Patent No.: US 7,151,218 B2

For: ELECTRICAL
TERMINATION
COMPONENT BRACKET

REQUEST FOR CERTIFICATE OF CORRECTION OF PATENT

FIG. 2

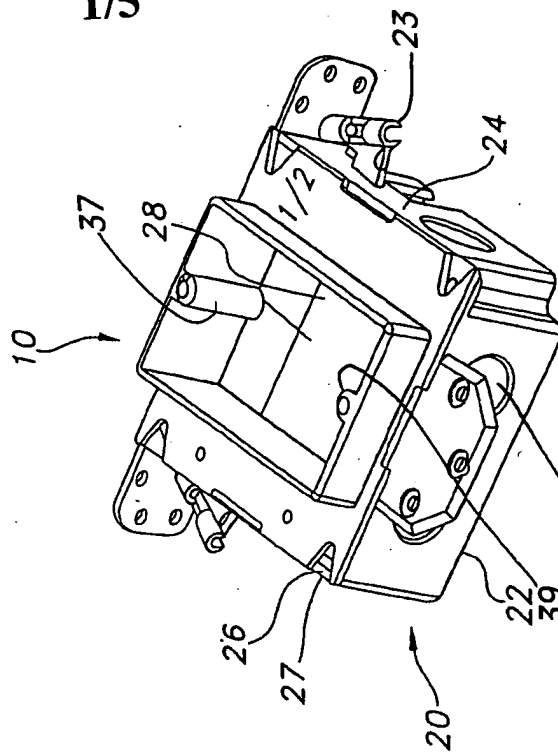
In Figure 2, previously omitted elements 21, 23, 37, and 39 have been added.

FIG. 1

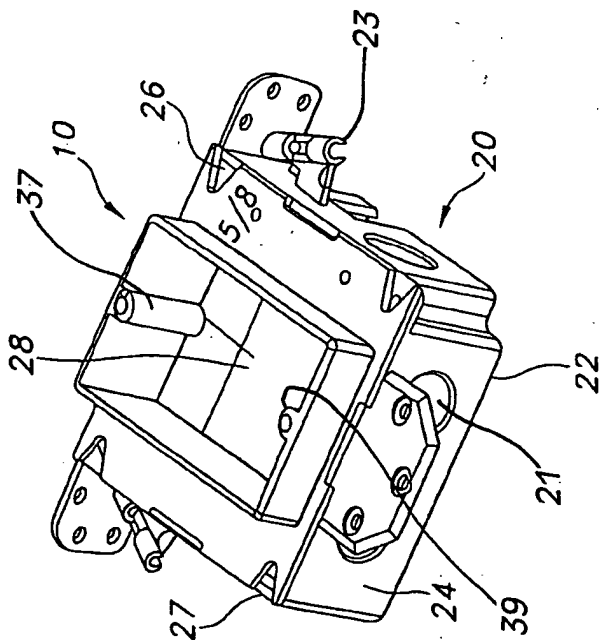
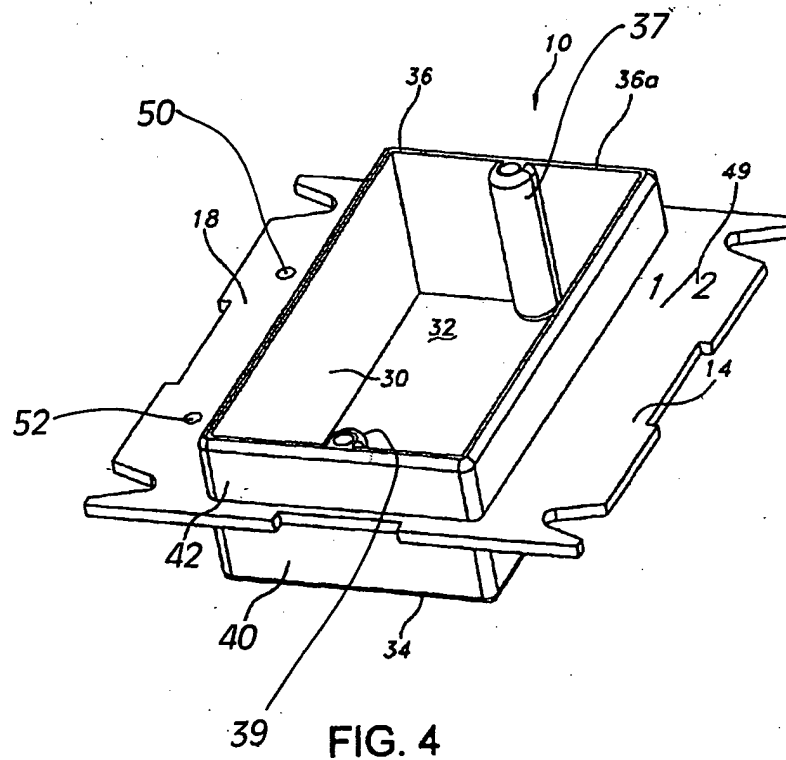
In Figure 1, previously omitted elements 21, 23, 37, and 39 have been added.

FIG. 5

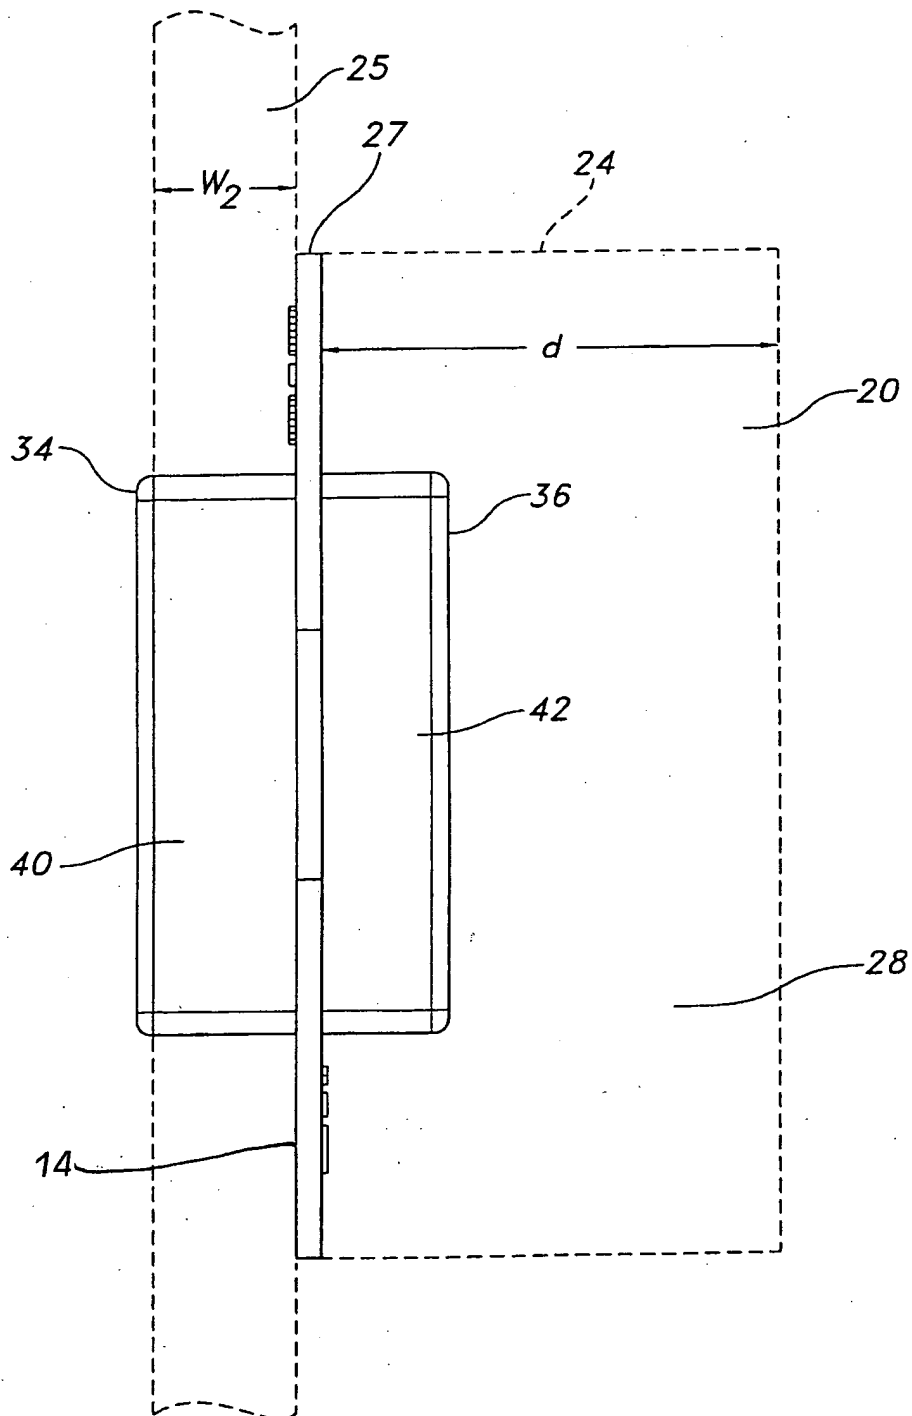
In Figure 5, previously omitted element 14 was added.

FIG. 6

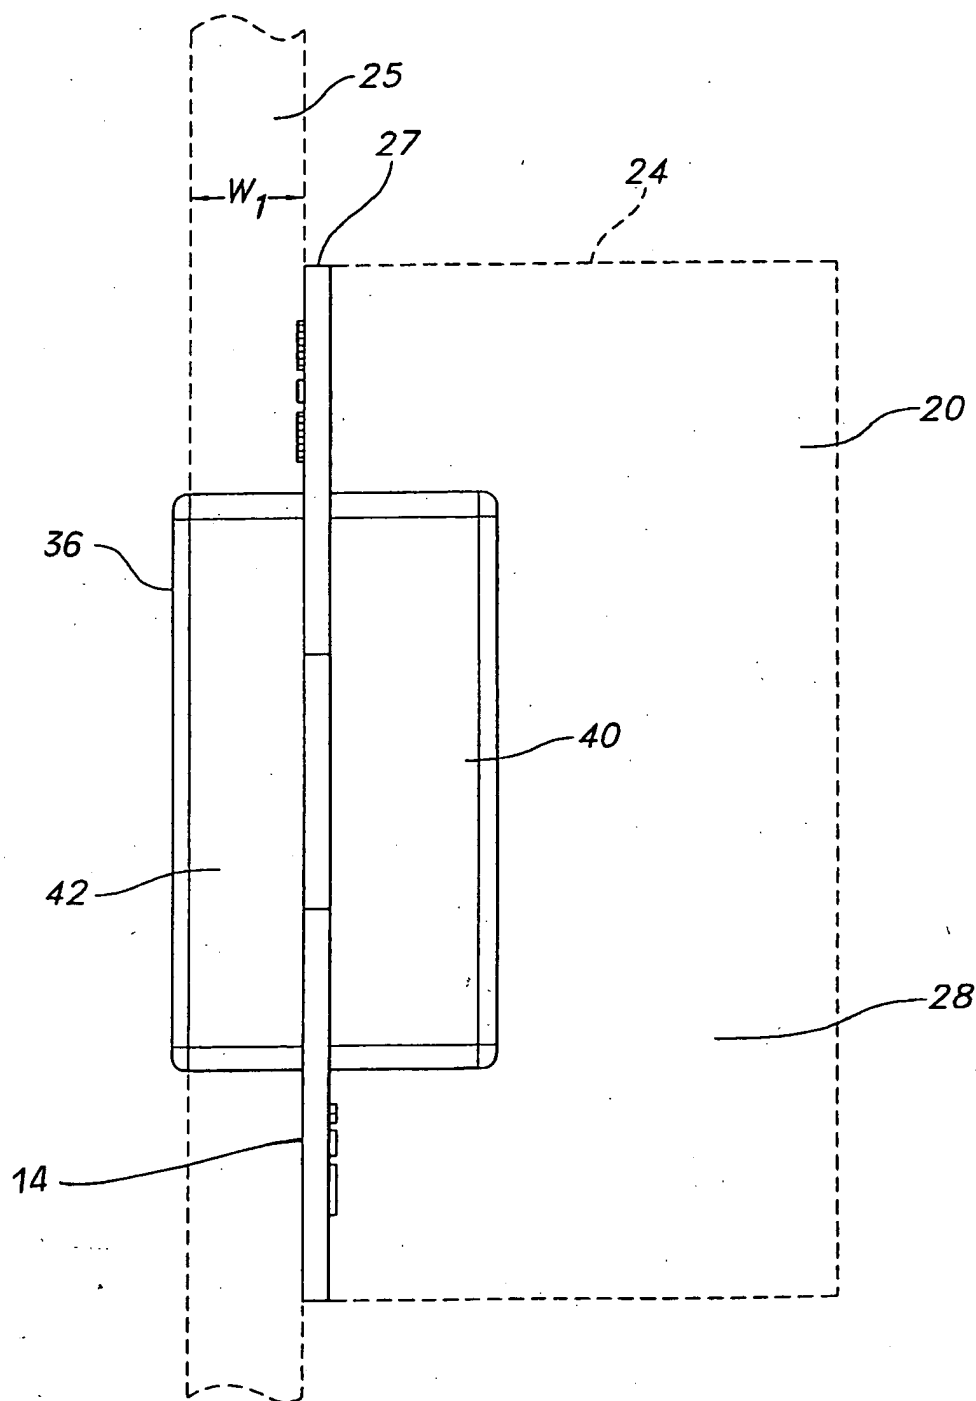
In Figure 6, previously omitted element 14 was added. Also, element "34" was replaced with element --36--.
